Access Compliance Report

Public Rights-of-Way

(Curb Ramps)

Intersection ID: 31301	Main Street: HOLBERT_CR	Cross Street: MUNSING_DR	Location:	E
ADA ID: CBF156C5416F	Ramp Type: PerpDiag	Initial Pass/Fail: Fail	Overall Compliance: No	Severity Score: 25
Codes/Mitigation Info/Possible Solution		Field Measurements/Component Compliance

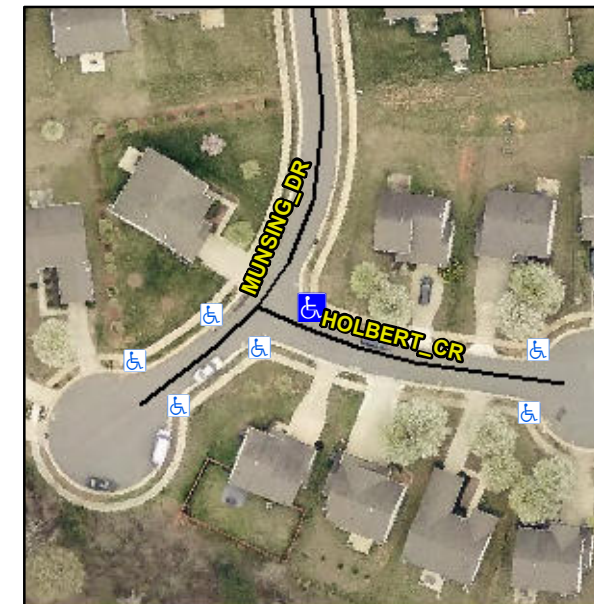
R304.2.2, R304.5.3

Compliance	Description	Data	Compliance	Description	Data
N/A	Ramp Length (in)	51.0	No	Ramp Slope (%)	9.7
Yes	Ramp Width (in)	48.0	No	Ramp XSlope (%)	6.8
N/A	Flare Type LT	N/A	N/A	Flare Type RT	N/A
N/A	Flare Slope LT (%)	N/A	N/A	Flare Slope RT (%)	N/A
N/A	Flare Traversable LT?	N/A	N/A	Flare Traversable RT?	N/A
N/A	Landing Length (in)	N/A	N/A	DWS Provided?	N/A
N/A	Landing Width (in)	N/A	N/A	DWS Contrast?	N/A
N/A	Landing Slope (%)	N/A	N/A	DWS Length (in)	N/A
N/A	Landing X Slope (%)	N/A	N/A	DWS Full Width?	N/A
N/A	Landing Curb? (Y/N)	N/A	N/A	DWS Offset (in)	N/A
N/A	Shared Landing?	N/A			
N/A	Gutter Ponding?	N/A	N/A	Gutter Slope (%)	N/A
N/A	Gutter Lip Ht (in)	N/A	N/A	Gutter X Slope (%)	N/A
N/A	Painted X Walk1?	No	N/A	Painted X Walk2?	No
	X Walk 1 Direction	To NW		X Walk 2 Direction	To S
N/A	X Walk 1 Width (in)	N/A	N/A	X Walk 2 Width (in)	N/A
	X Walk 1 Slope (%)	8.0		X Walk 2 Slope (%)	6.5
	X Walk 1 X Slope (%)	0.6		X Walk 2 X Slope (%)	4.9

N/A	Ramp inside XWalk1?	N/A	N/A	Ramp inside XWalk2?	N/A
	Road Slope (%)	5.3	N/A	Clear Space?	N/A
	Road X Slope (%)	3.9	N/A	Clear Space to XWalk (in)	N/A
N/A	Any Obstructions?	N/A	N/A	Storm Grate/Utility Hazard?	N/A
	Obstruction Type			Storm Grate/Utility Type	
		N/A			N/A
		Yes		Surface Condition? (G/P)	Good

Remove & Replace Curb Ramp With Two New Directional Ramps or Equivalent.
